Site Based Stormwater Management Report

893-899 Stanley St & 10 Hampton St
East Brisbane

PLANS AND DOCUMENTS
referred to in the PDA
DEVELOPMENT APPROVAL

AMENDED IN RED

CLIENT	DAKL GROUP
TITLE	SITWORKS LAYOUT PLAN

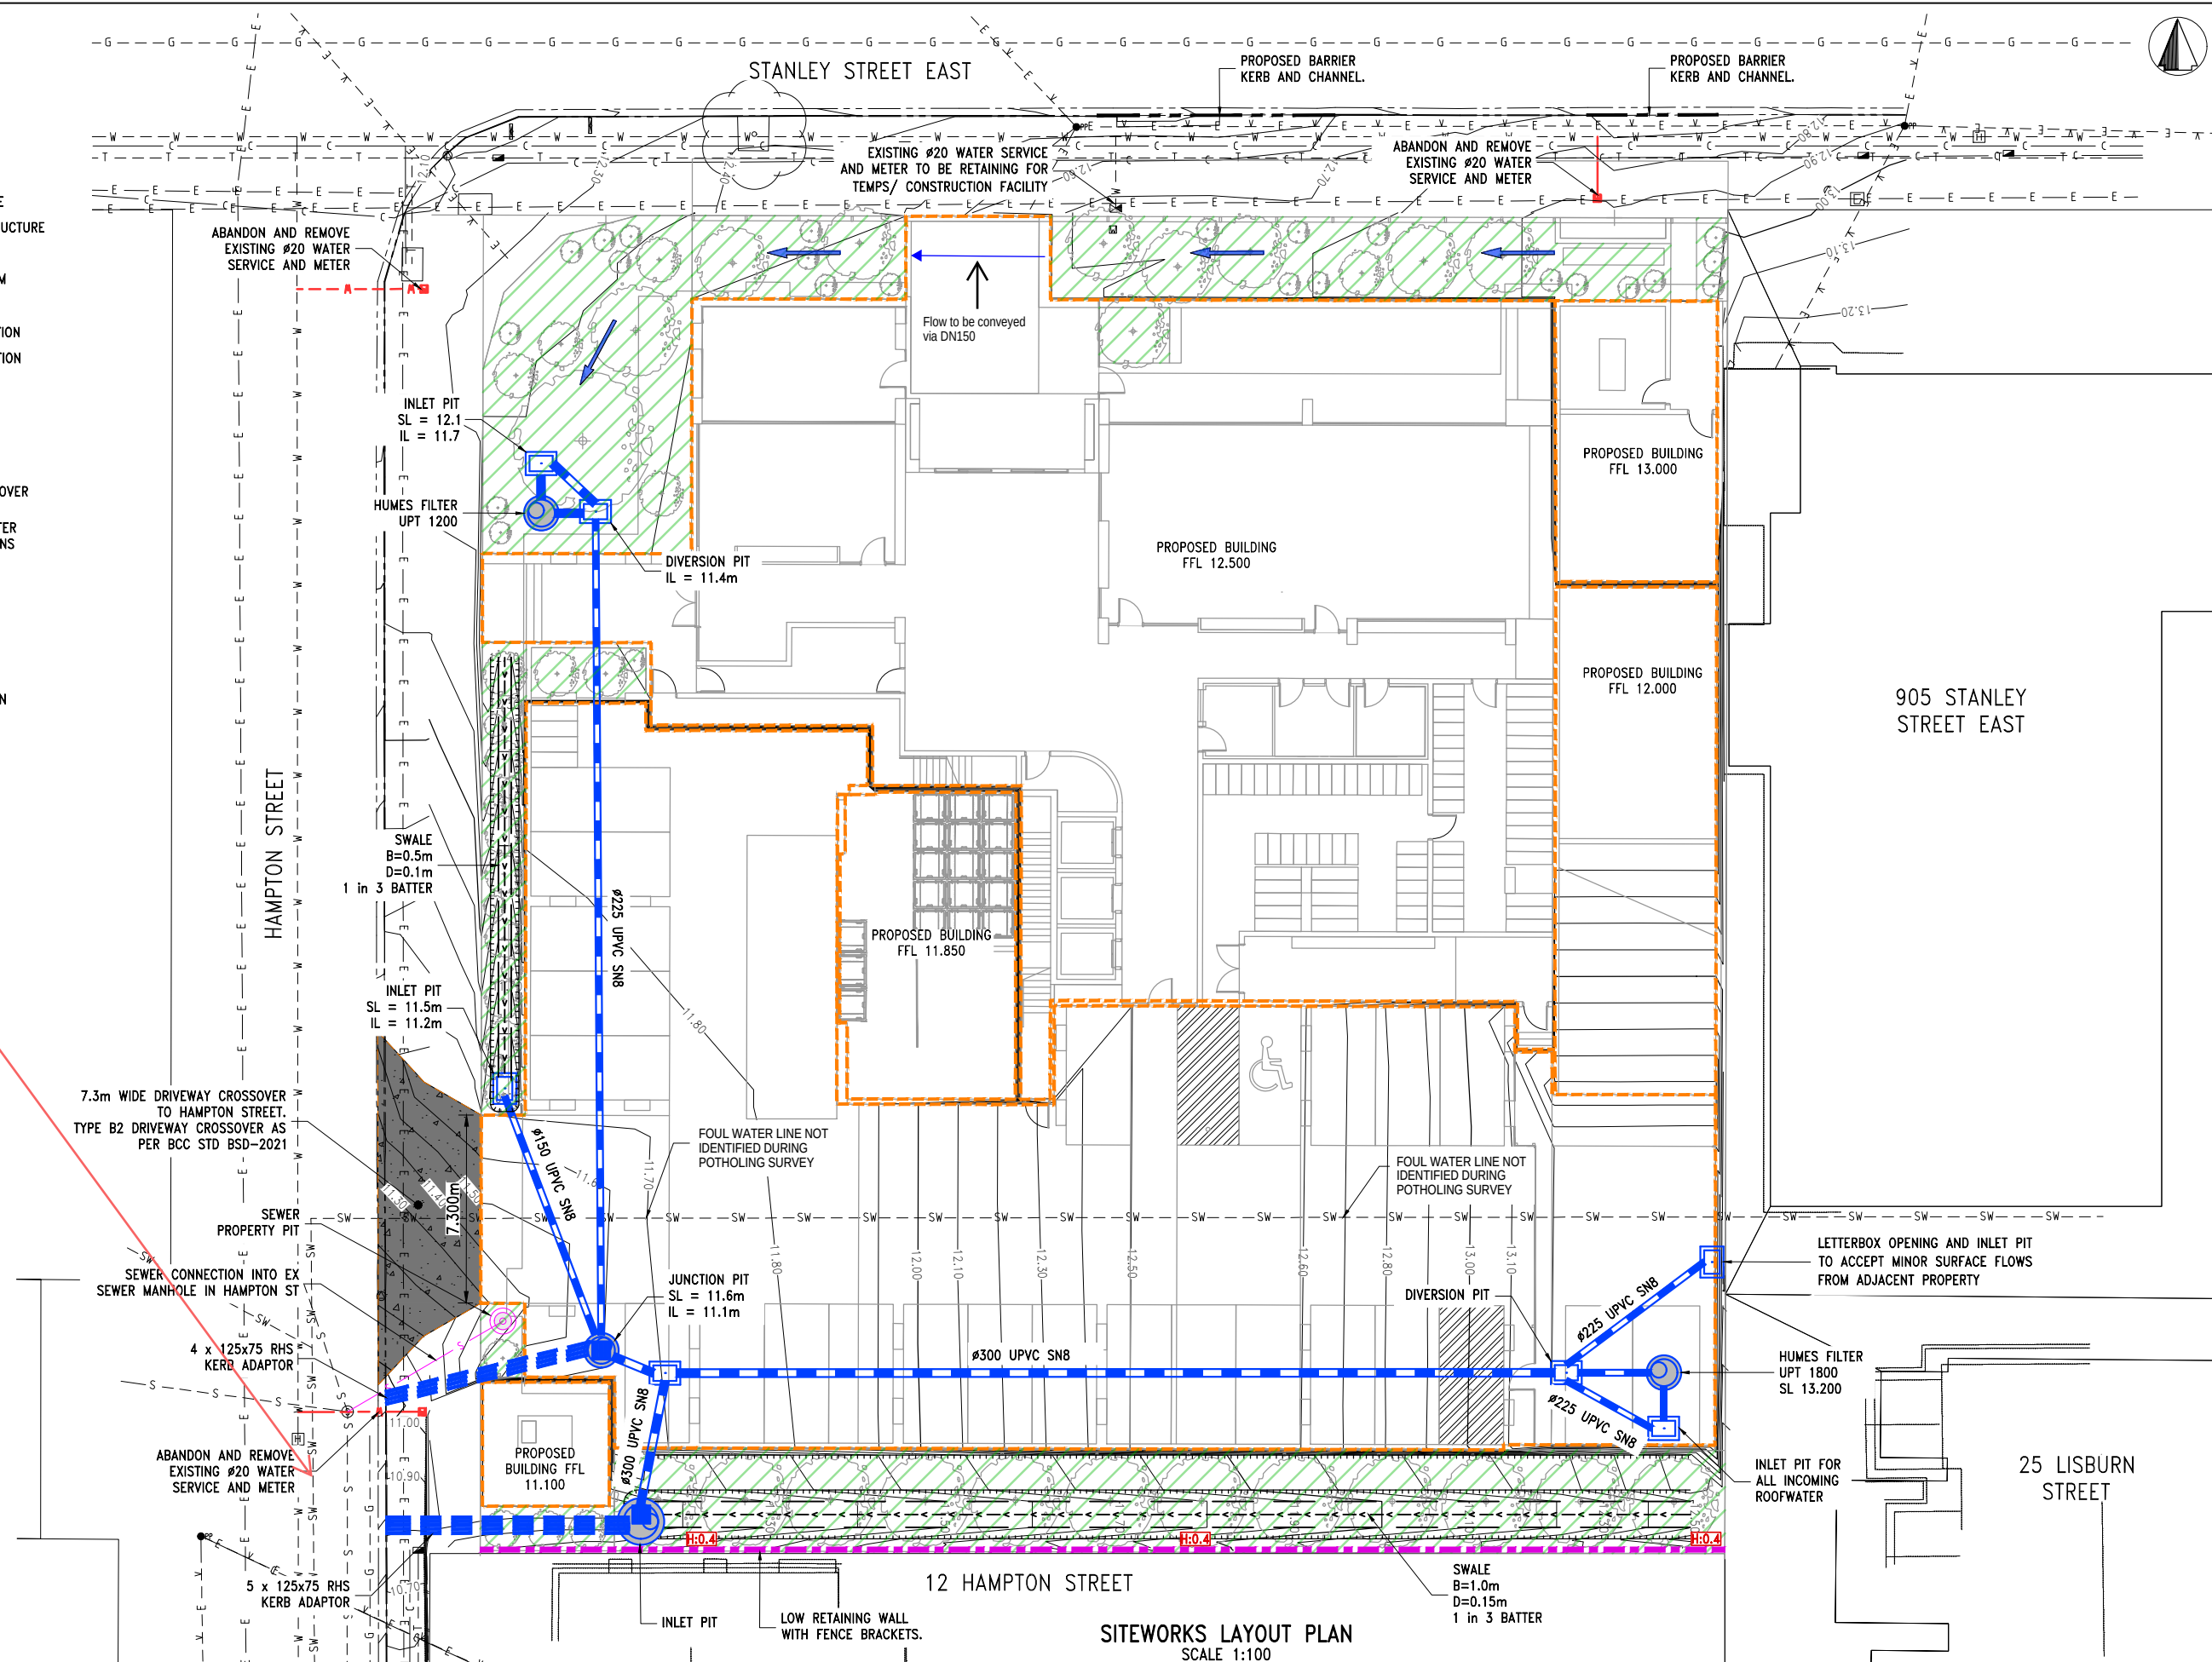
See amendments
in red to drawing
number C200,
contained in
Appendix C.

Discharge arrangement subject to compliance assessment approval, as per condition 28.
